U.S. Department
of Transportation
Federal Aviation
Administration

Subject: Dynamic Evaluation of Seat Restraint Systems and Occupant Protection on Transport Airplanes

AC No: 25.562-1B
Change: 1

2. PRINCIPAL CHANGES. Change 1 updates AC 25.562-1B, *Dynamic Evaluation of Seat Restraint Systems and Occupant Protection on Transport Airplanes*, dated January 10, 2006. We have added the change number and date of revision at the top of each changed page. We have also marked the changes with a vertical change bar in the margin. Specifically, Change 1 incorporates the following changes:

Figure 5-2. Structural Test Article Decision Tree for Seat Family

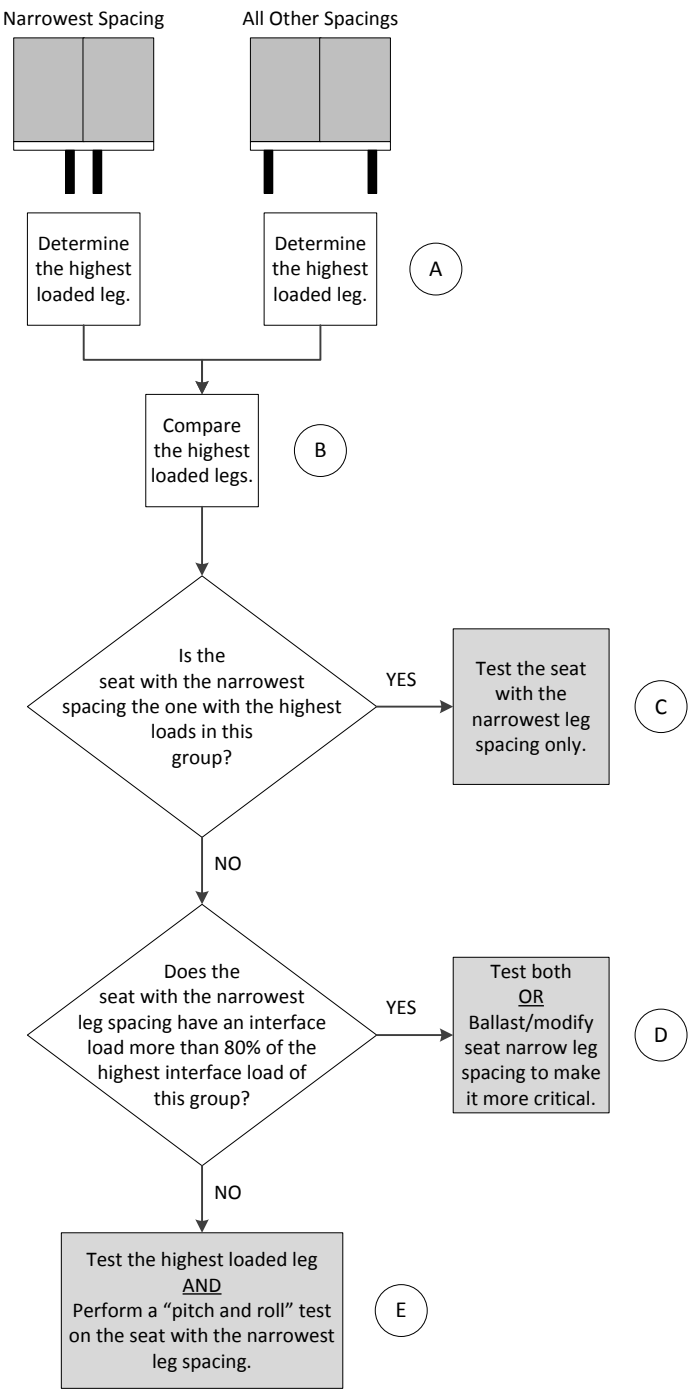
b. Corrects typographical errors in the second question of Figure 5-2. We also redesigned the figure to improve readability.
